ADDENDUM 01

PROJECT: Cherokee Nation of Oklahoma

Jack Brown Center - Phase II

PROJECT #: 24-08.59

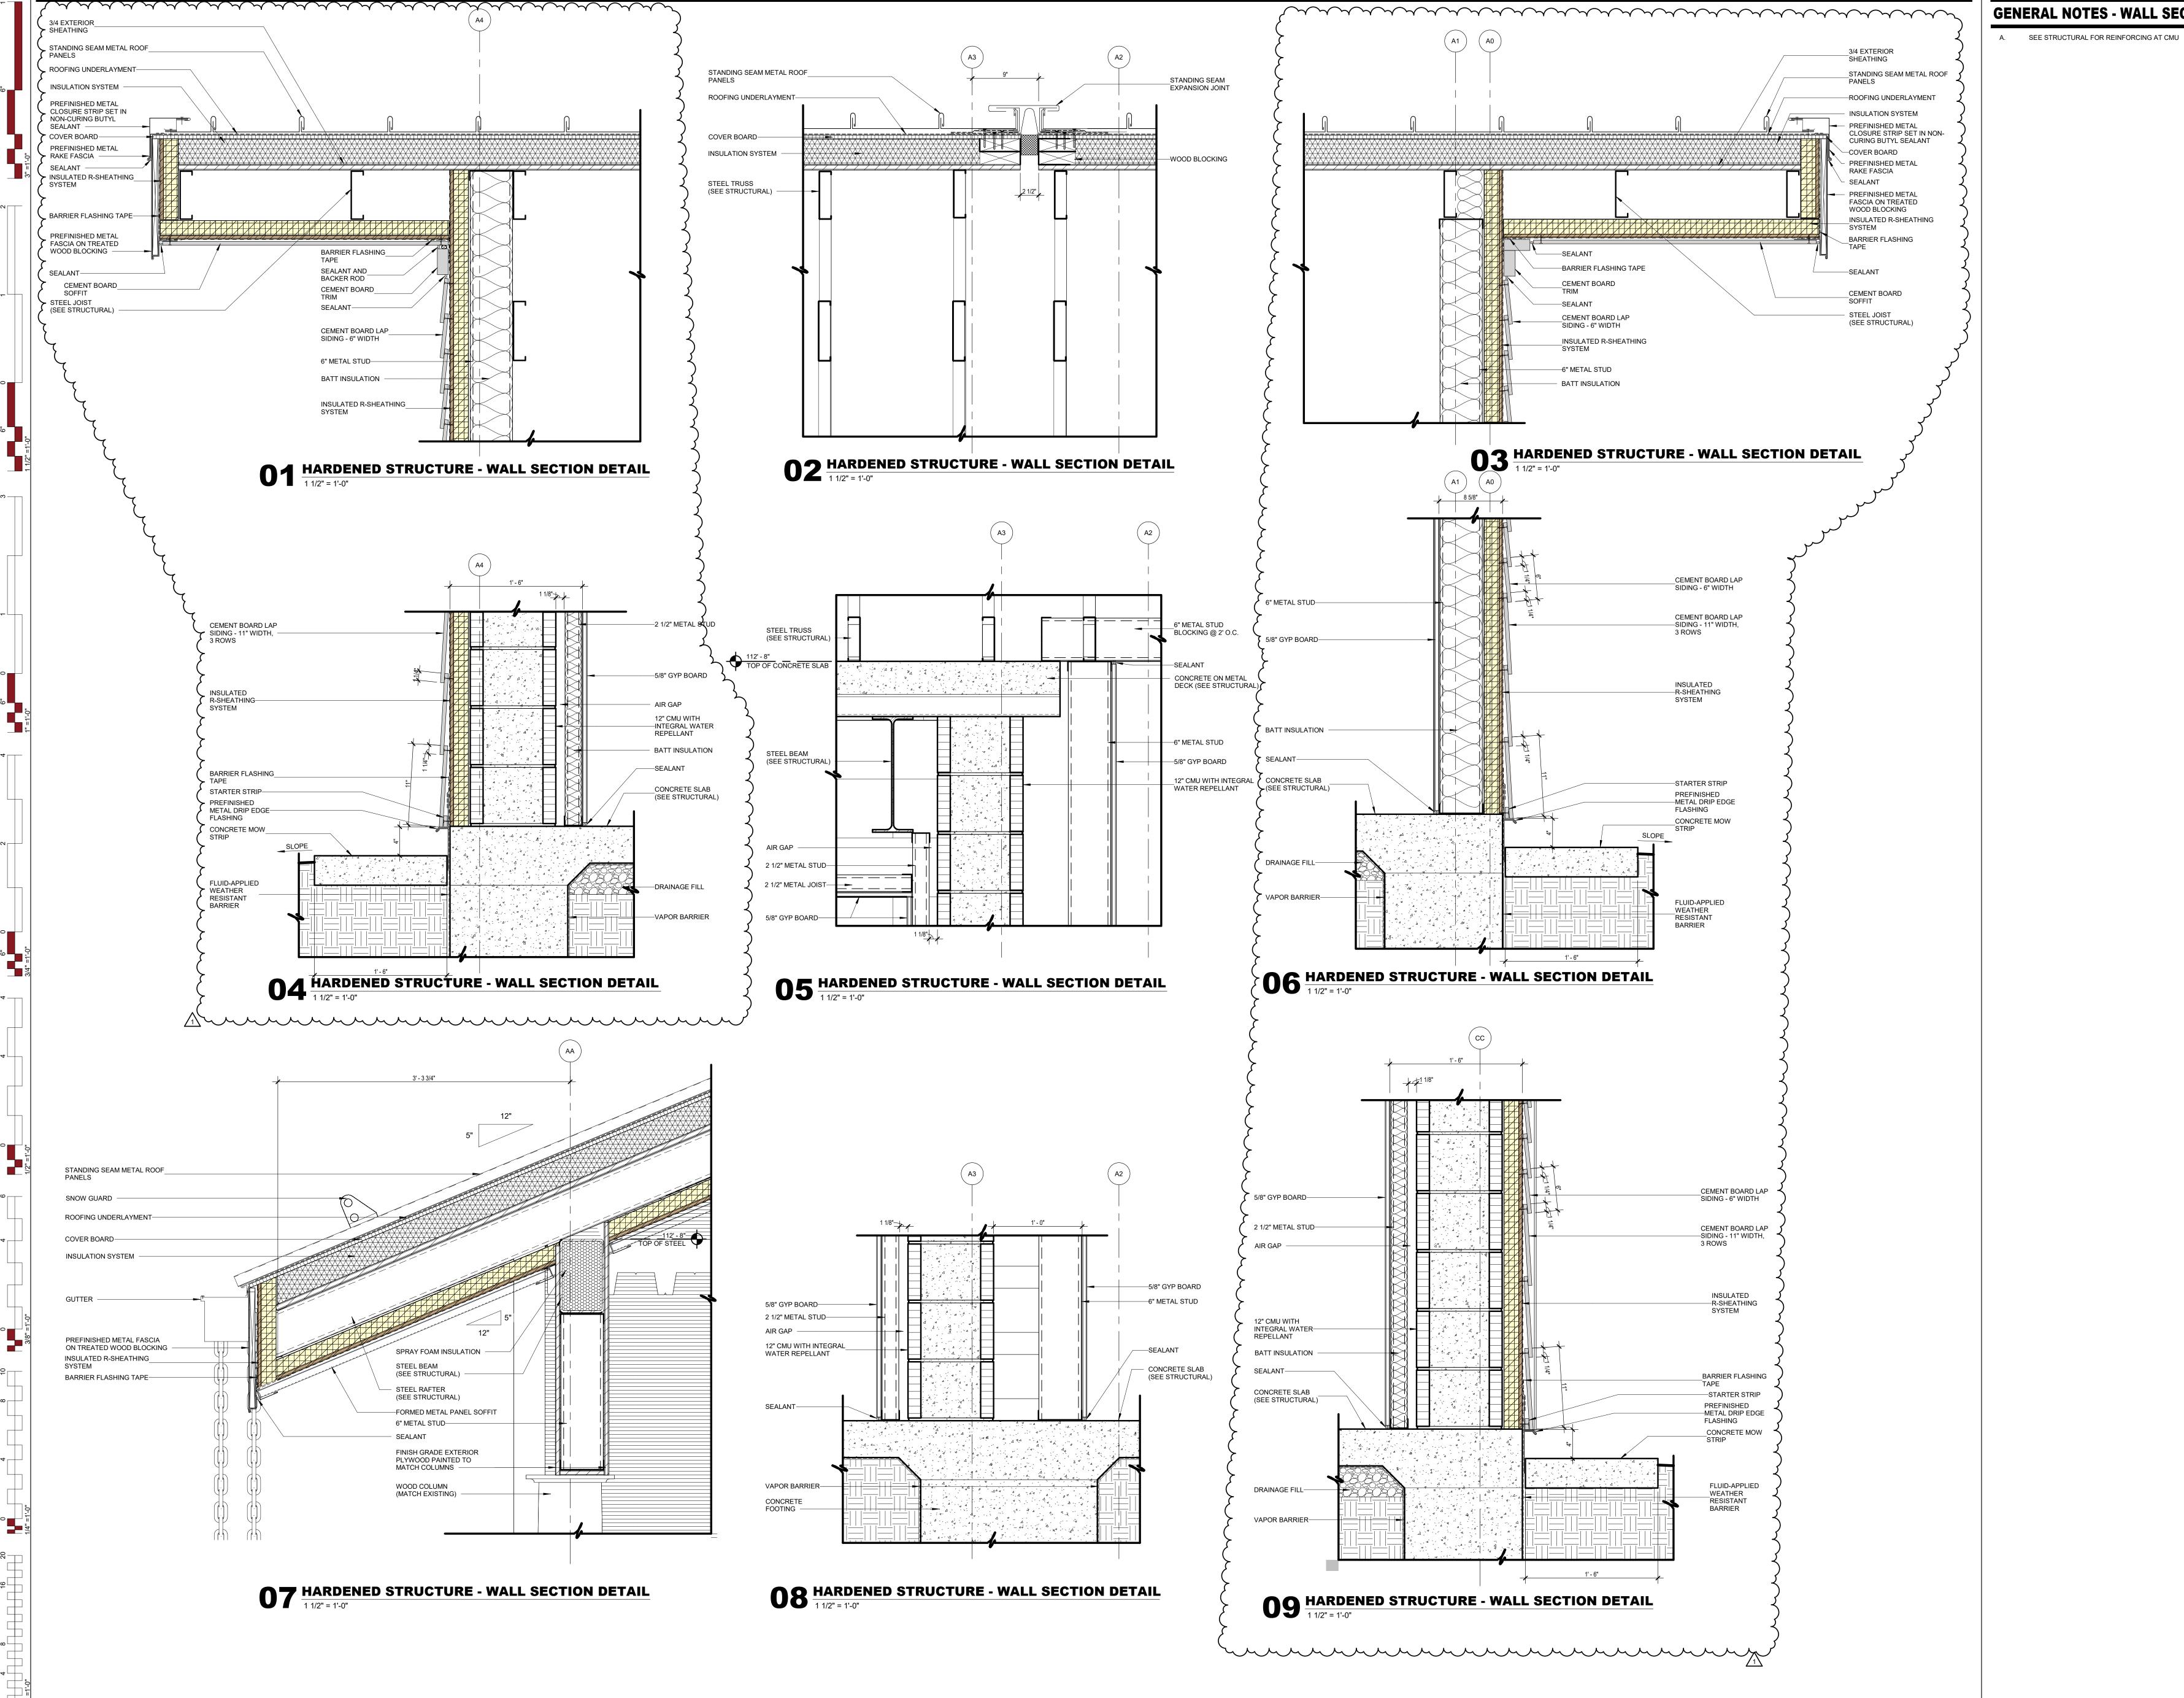
2. M/E/P: Substitution request for alternate A/C unit. See attached

1. The following manufacturers have requested permission to offer their products as base bid material and further allege that they conform to the Drawings and Specifications. This listing does not abrogate the Drawings and Specifications in any way, and final compliance rests with the bidding contractor. All piping, electrical wiring, structural, etc., or other mechanical and electrical revisions required to enable the following equipment to be used on the job shall be the responsibility of the bidding contractor. The job is designed to ensure the specified equipment will fit into the allotted space. Any size deviations resulting from the substituted equipment shall be the responsibility of the bidding contractor.

Product	Specification Section	Manufacturer
Packaged Roof Top Air Conditioner Schedule	23 7413	Tempmaster Omni Core

A5.01-H

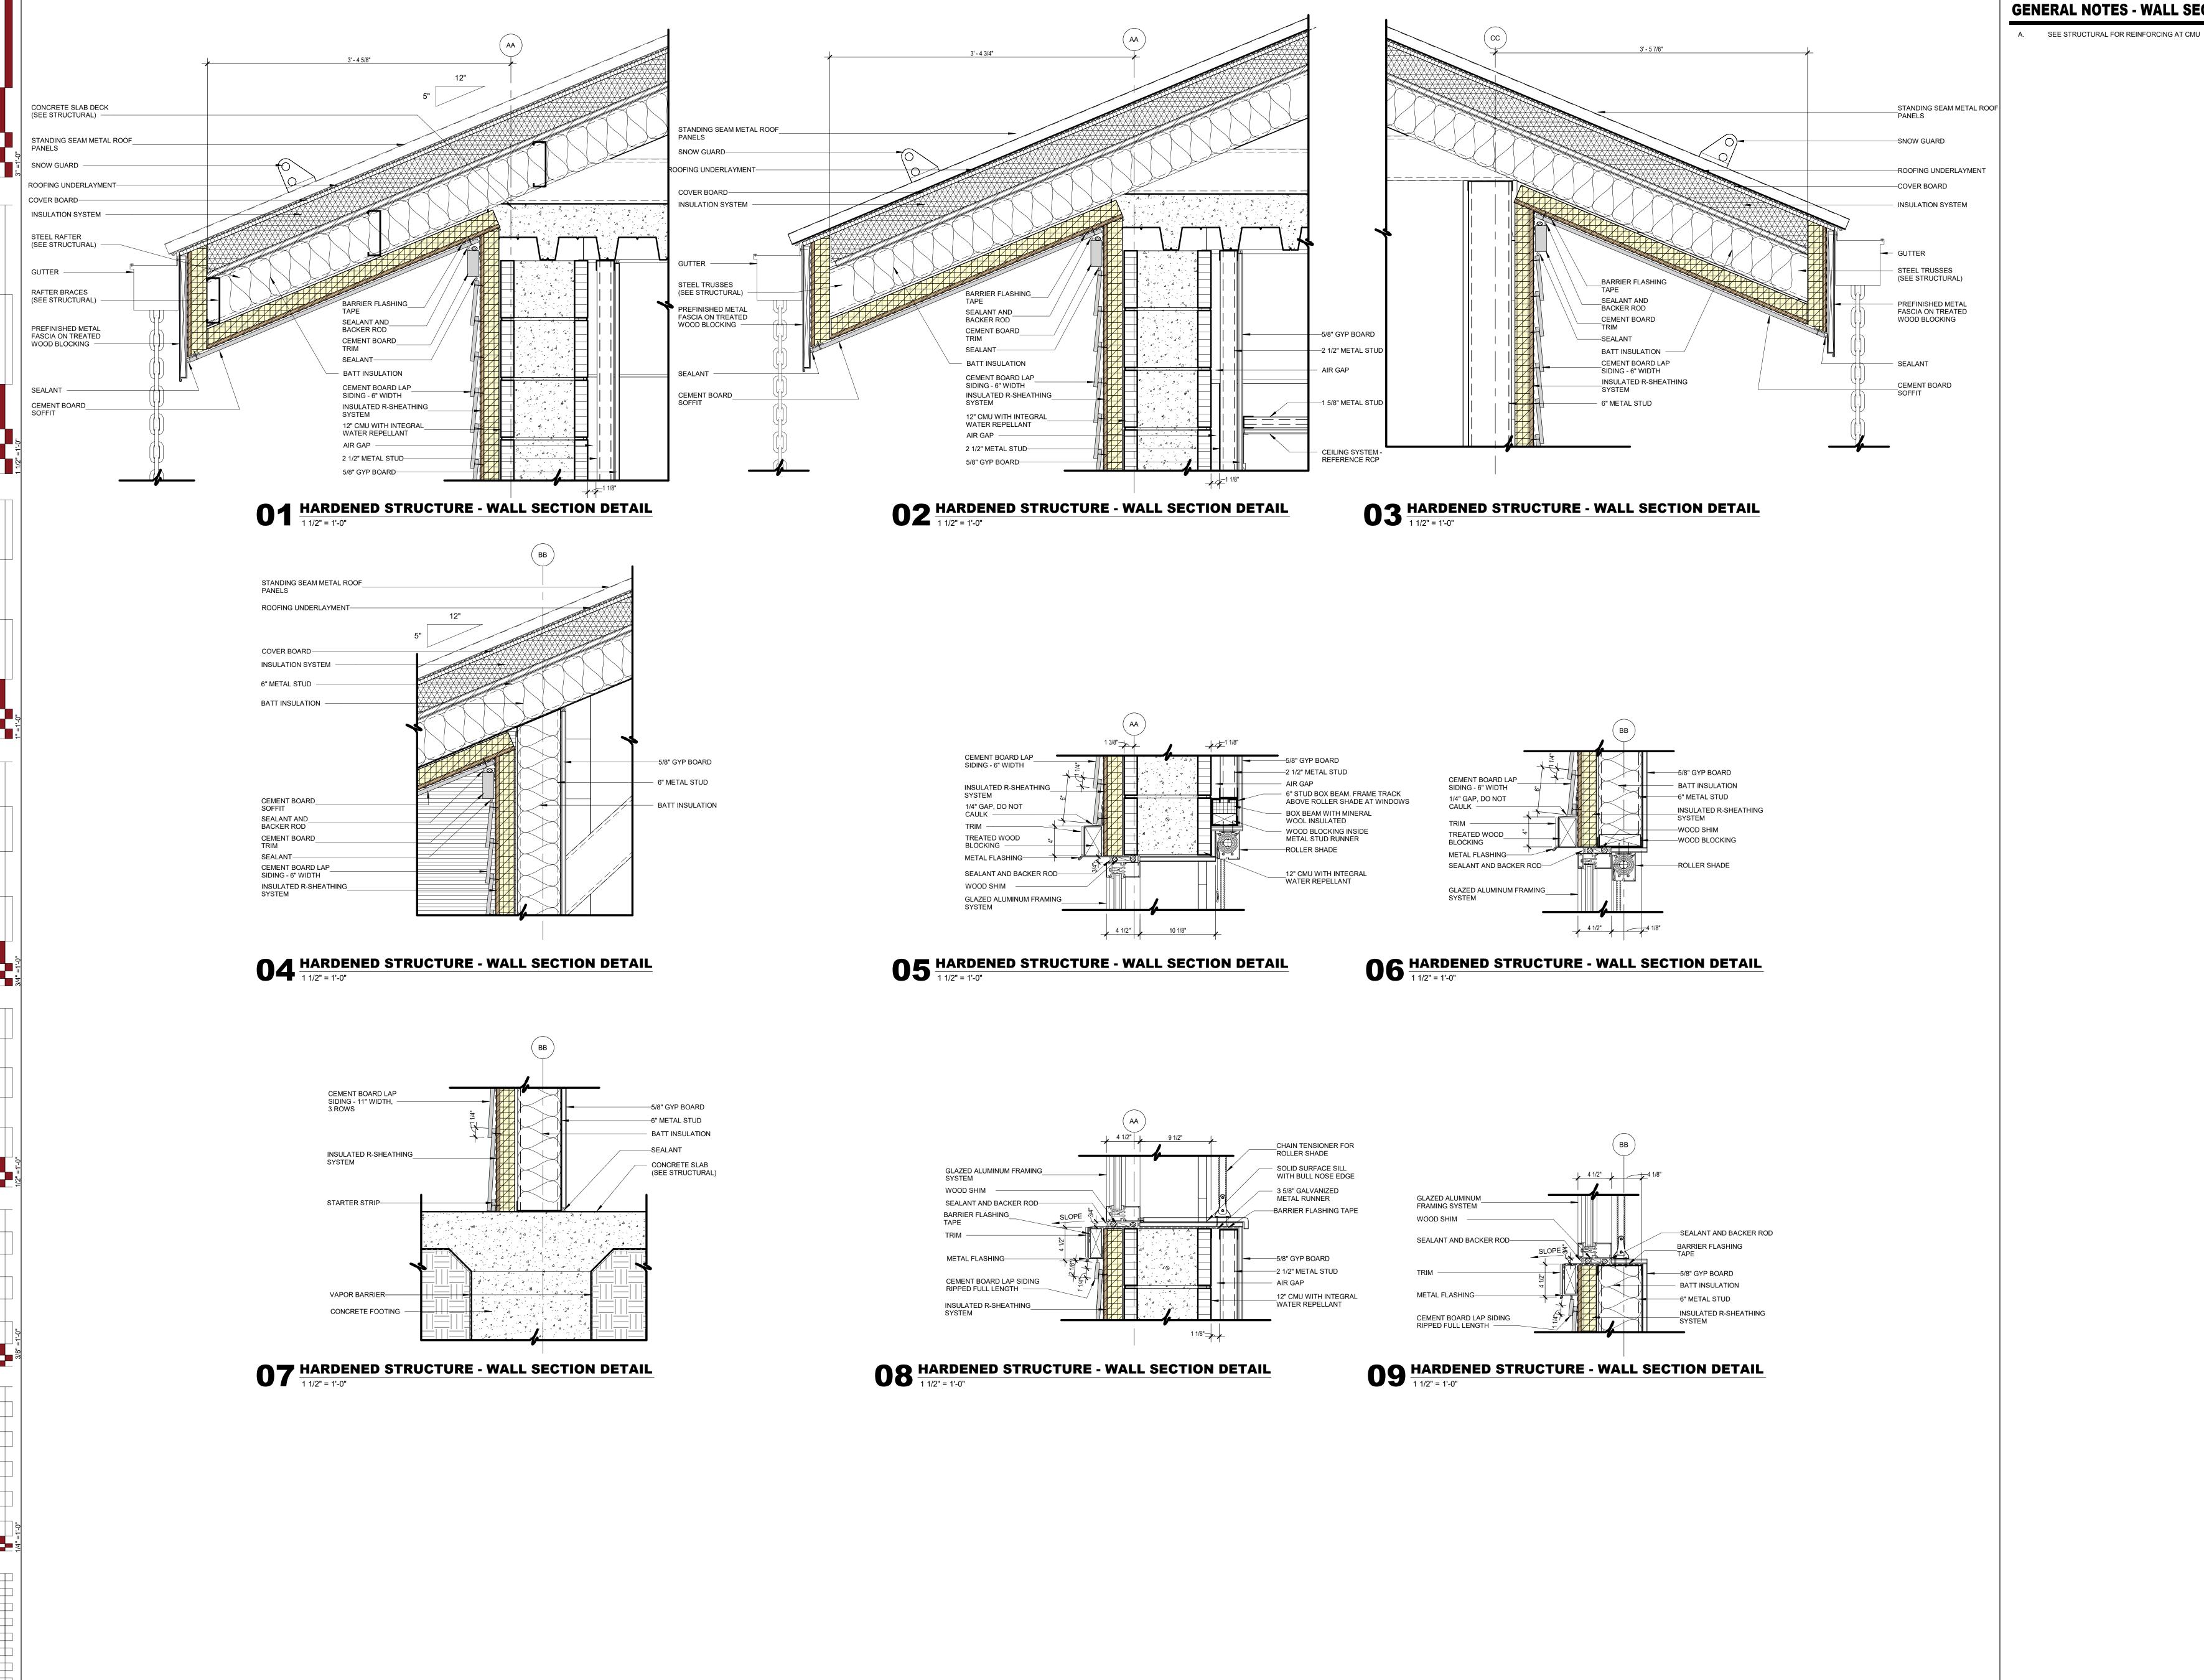
3. Substitute Fiber Cement plank siding in lieu of metal siding. Affected sheets/details: (Revised sheets found at the end of Addendum 01):

- a. Sheet A5.01-H, details 01, 03, 04, 06, 09
- b. Sheet A5.02-H, details 01, 02, 03, 04, 05, 06, 07, 08, 09
- c. Sheet A5.40-H, details 01, 02, 03, 04, 06, 07, 08, 09, 11, 12, 13
